Subject: **Modification of Section 404 Nationwide Permit 13 and 33 and Modification of Section 401 Water Quality Certification** for the proposed replacement of Bridge No. 215 over Mountain Creek on SR 1542 in Stanly County, Federal Aid Project No. BRZ-1542(7), Division 10, TIP No. B-5137, Debit \$240 from WBS 42296.1.1.

Reference: Section 404 Nationwide 13 and 33 Permit, Action ID 2012-00790 issued July 25, 2013.
Section 401 Water Quality Certification, DWQ No. 13-0718, issued July 23, 2013.

LOCATION: REPLACE BRIDGE NO. 215 OVER MOUNTAIN CREEK
ON SR 1542 (RIDGE RD.)

SHEET 3 OF 7

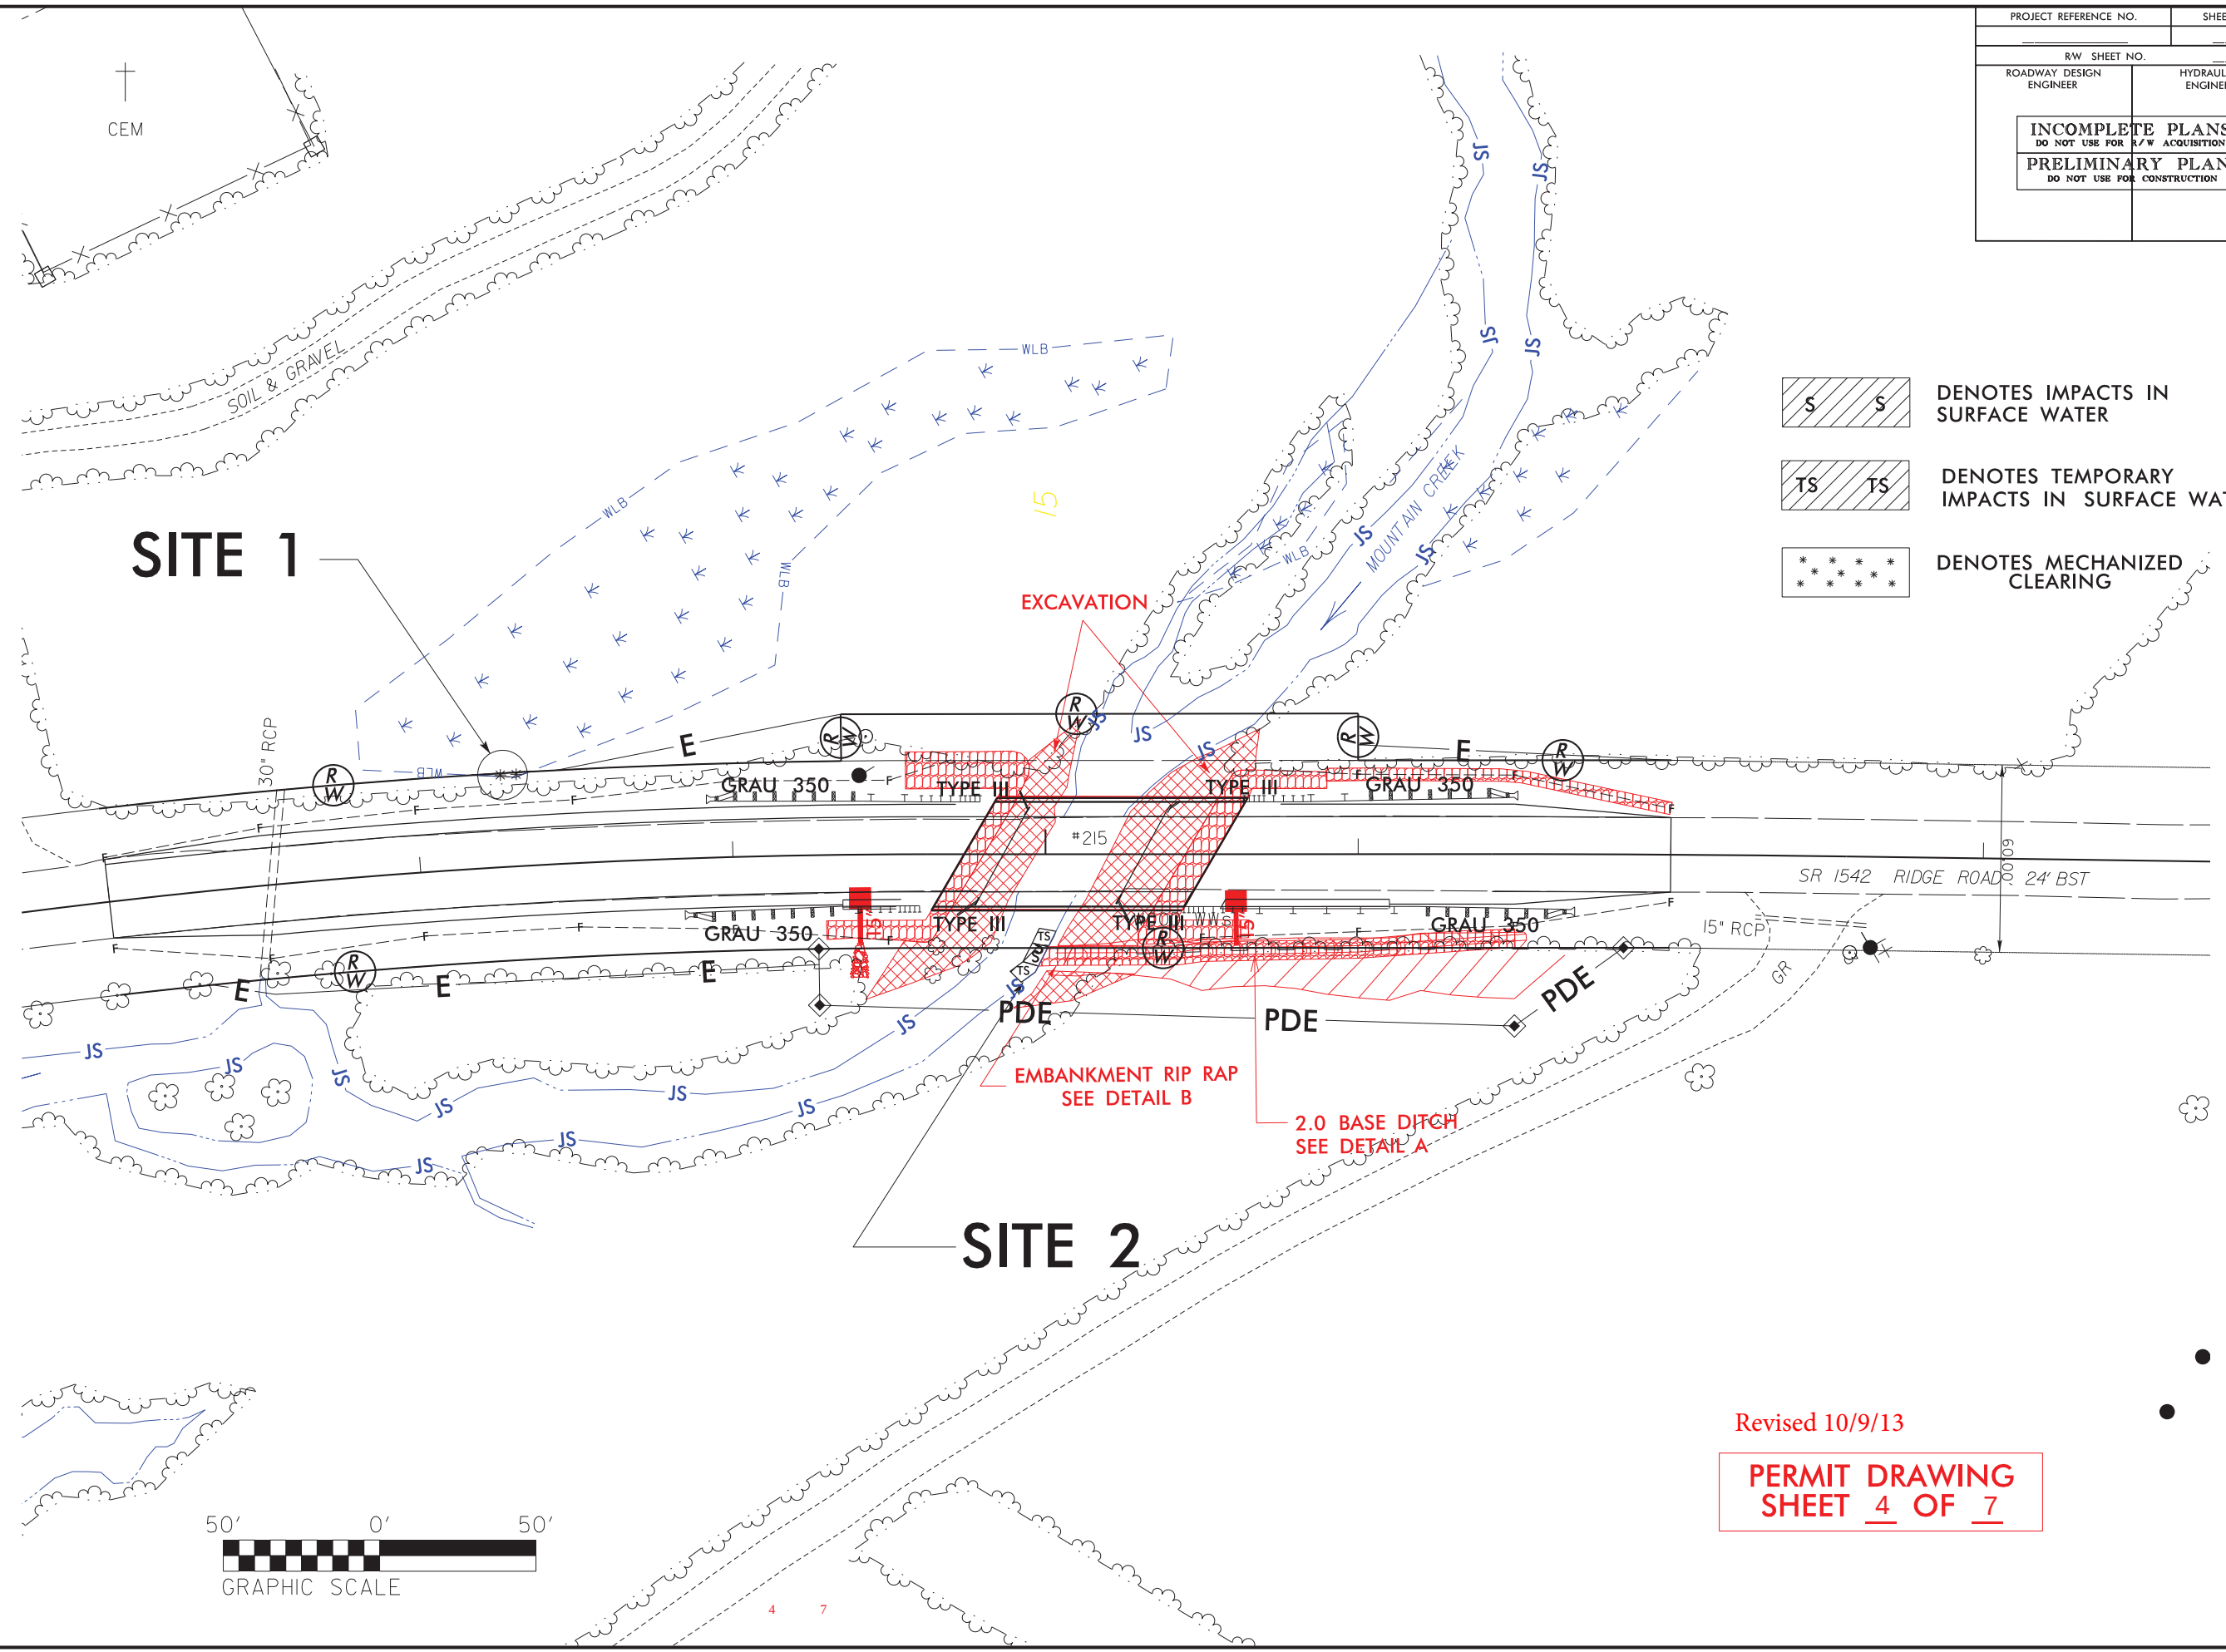
The proposed structure for the above referenced project has been changed from a two-span to a single-span bridge. Due to this design revision, the amount of stream bank stabilization at the outlet of the base ditch has been reduced from 8 to 7 linear feet.
